Variance Petition No. V12-008

**CITY OF SANDY SPRINGS
DEPARTMENT OF COMMUNITY DEVELOPMENT
VARIANCE ANALYSIS**

CASE NUMBER: V12-008

Parcel Map

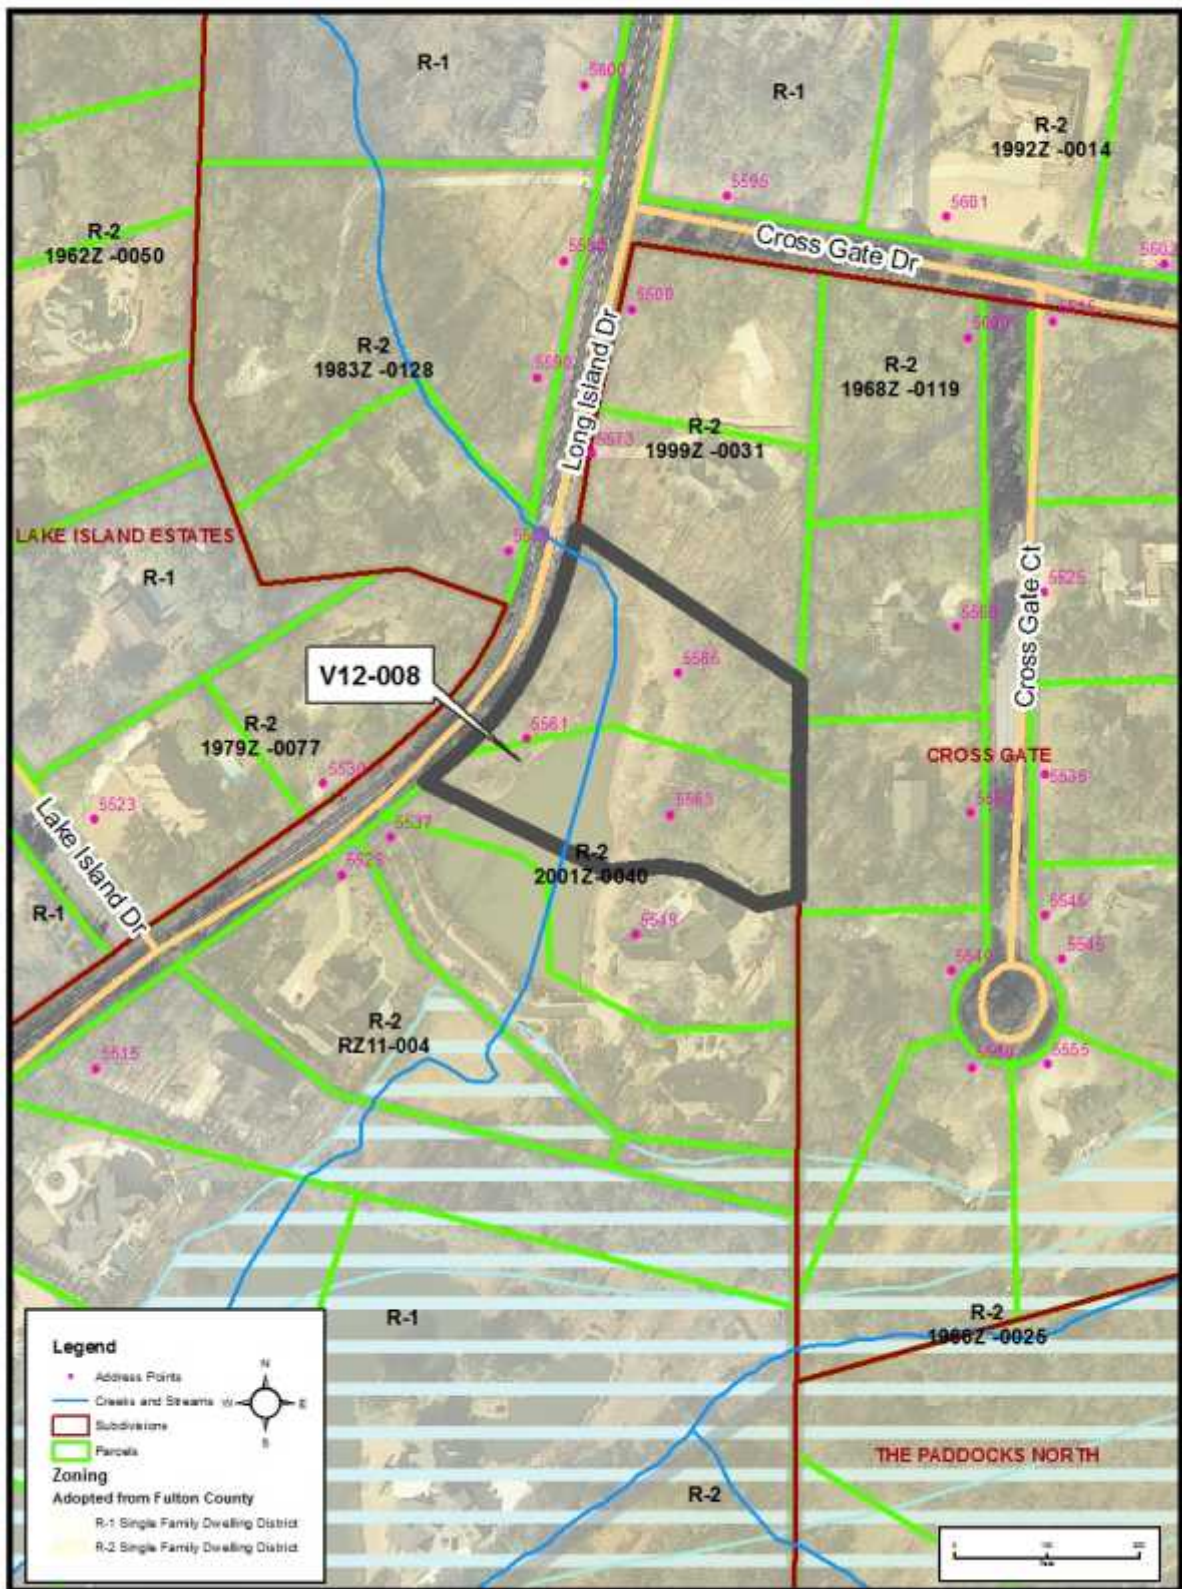
The applicant is proposing to construct a joint use driveway and bridge with a crossing perpendicular to the existing lake; the driveways would then run alongside the existing lake. The non-perpendicular portions of the proposed driveway would encroach into the seventy-five (75) foot impervious setback. The applicant is requesting one (1) primary variance from the Stream Buffer Protection Ordinance:

1. Section 109-225.a 1 and 2 of the Stream Buffer Protection Ordinance to reduce seventy-five (75) foot impervious surface setback to twenty-five (25) feet to allow for the construction of a joint use driveway and sidewalk.

V12-008 – 1) APPROVAL CONDITIONAL
